Humboldt Bay Municipal Water District 12 kV Switchgear Relocation Project Bid Addendum #2

This Addendum addresses the following items:

Client	HUMBOLDT BAY MUNICIPAL WATER DISTRICT	
Project	12 kV SWITCHGEAR RELOCATION	
Title	CIVIL SITE PLAN	
Project No.	11186675	
Original Size	ANSI D	
Sheet No.	C-101	
Sheet	3 of 24

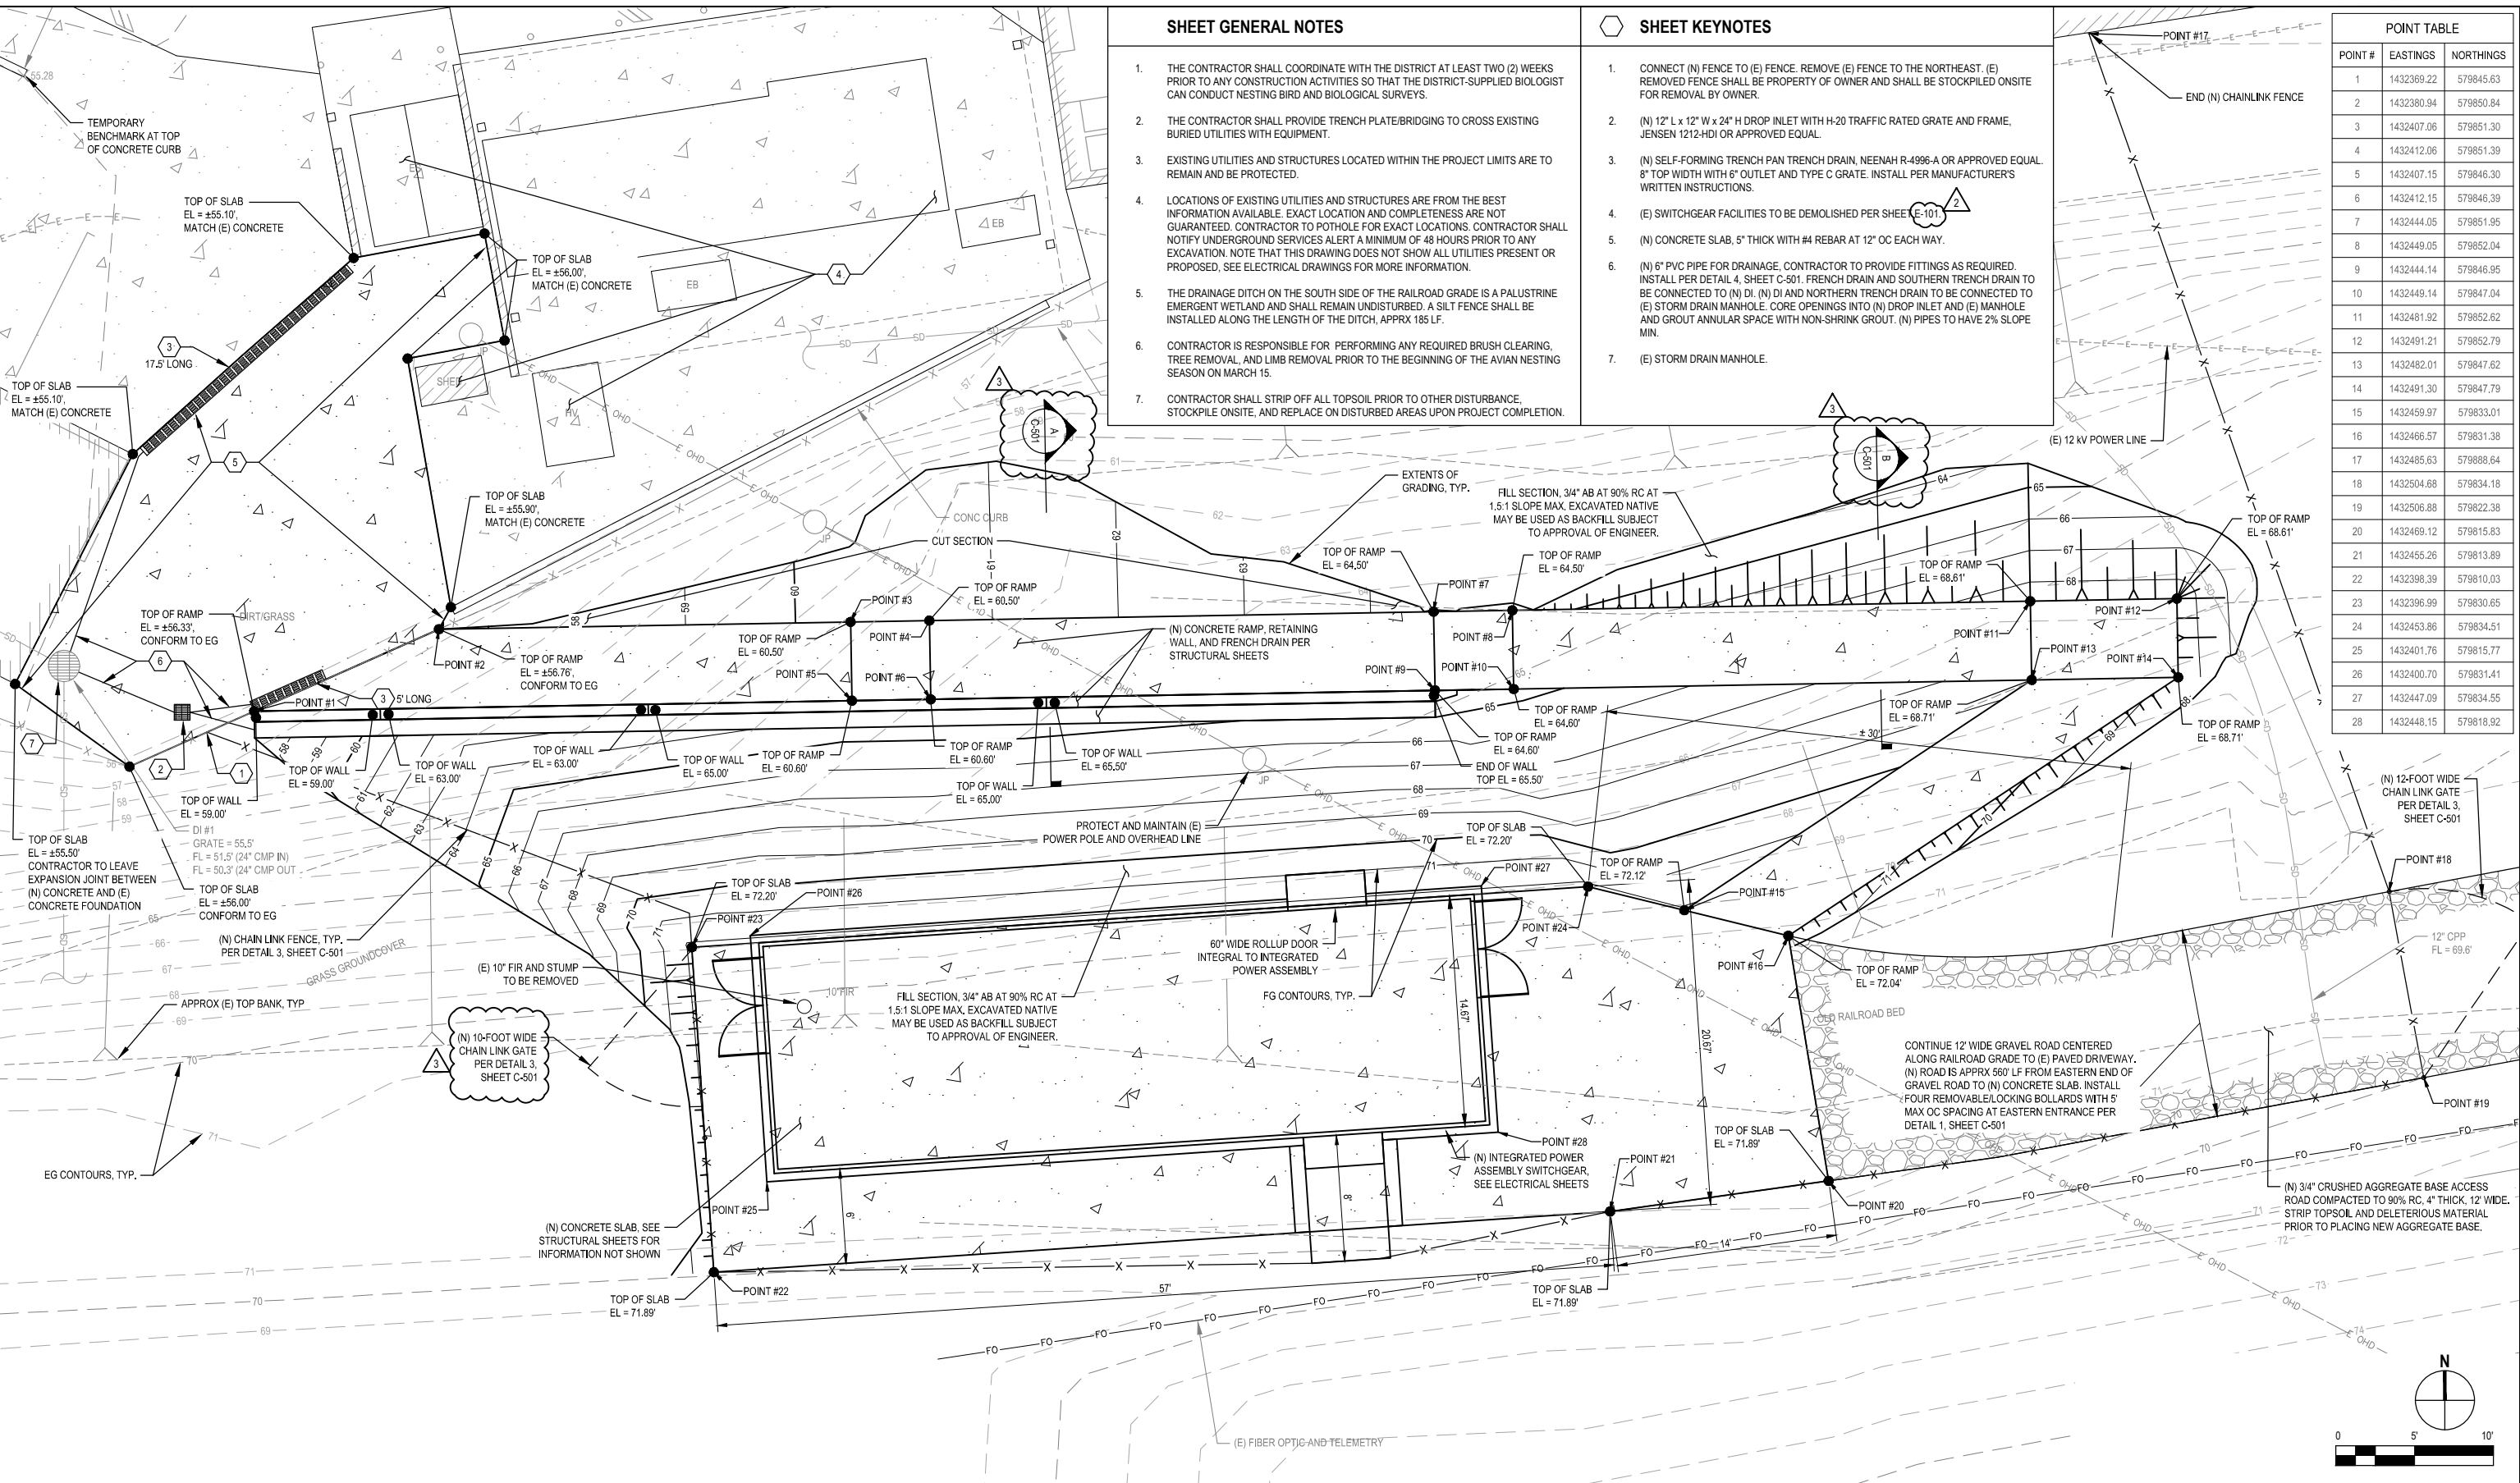
1. A new gate will be installed on the west side of the Integrated Power Assembly. Sheet E-401 shows the southern gate post very near the new underground utility trench coming to/from Vault V-1. To give more space between this post and the utility trench, the gate shall be decreased from 12 feet long to 10 feet, with the hinge point remaining in the same location. This change has been made on the following attached revised Sheets: C-101, C-501, and E-401.
2. Sheet C-101 references two sections at the concrete ramp: Section A, Sheet C-301; and Section B, Sheet C-301. There is no Sheet C-301 in the Contract Drawings. These section references shall be updated to reference Sections A and B on Sheet C-501, as shown in the attached revised Sheet C-101.
